**BEFORE THE PUBLIC UTILITY COMMISSION
OF OREGON**

LC 62

In the Matter of)	
)	
PACIFICORP, dba PACIFIC POWER,)	OPENING COMMENTS OF THE
)	INDUSTRIAL CUSTOMERS OF
2015 Integrated Resource Plan.)	NORTHWEST UTILITIES
_____)

FIGURE 1^{18/}
Bi-Monthly Average CPS2 Performance
Calendar Year 2014

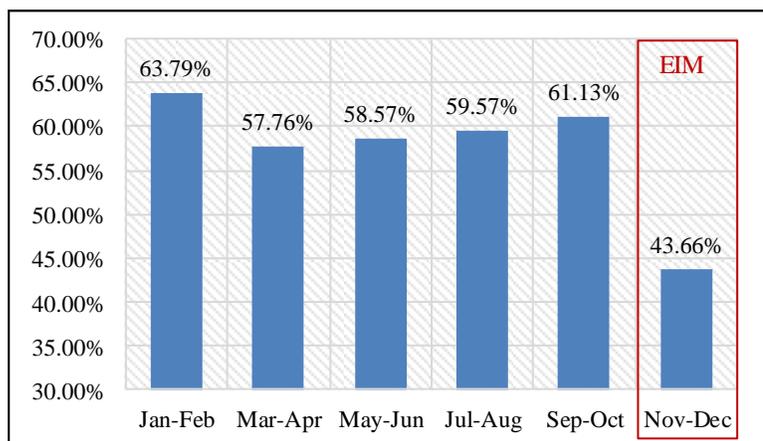
In addition, there is further evidence that the Company's participation in the Energy Imbalance Market ("EIM") has added further flexibility surrounding how the Company holds reserves. Figure 1, below, details the Company's CPS2 performance calculation over 2014, including November 2014 and December 2014, when the EIM began operations.

As can be noted from Figure 1, there was a material reduction to the CPS2 measurements in the period of November 2014 and December 2014, corresponding to the Company's entrance into the EIM. This is an indication that the Company has been able to relax

the level of reserves being held, while maintaining a high degree of system reliability, due to its participation in the EIM.

Based on the foregoing information, ICNU believes that PacifiCorp's wind integration study, based on the equivalent of 99.7% CPS2 performance, severely overstates the cost of wind integration on its system, and that the Company should be required to prepare a new wind integration study that properly accounts for the BAAL reliability standard. At a minimum, Company should be required to calculate wind integration costs based on a level of reserves that is equal to or less than the amount necessary under the lower bound of CPS2 requirement, or 90% exceedance.
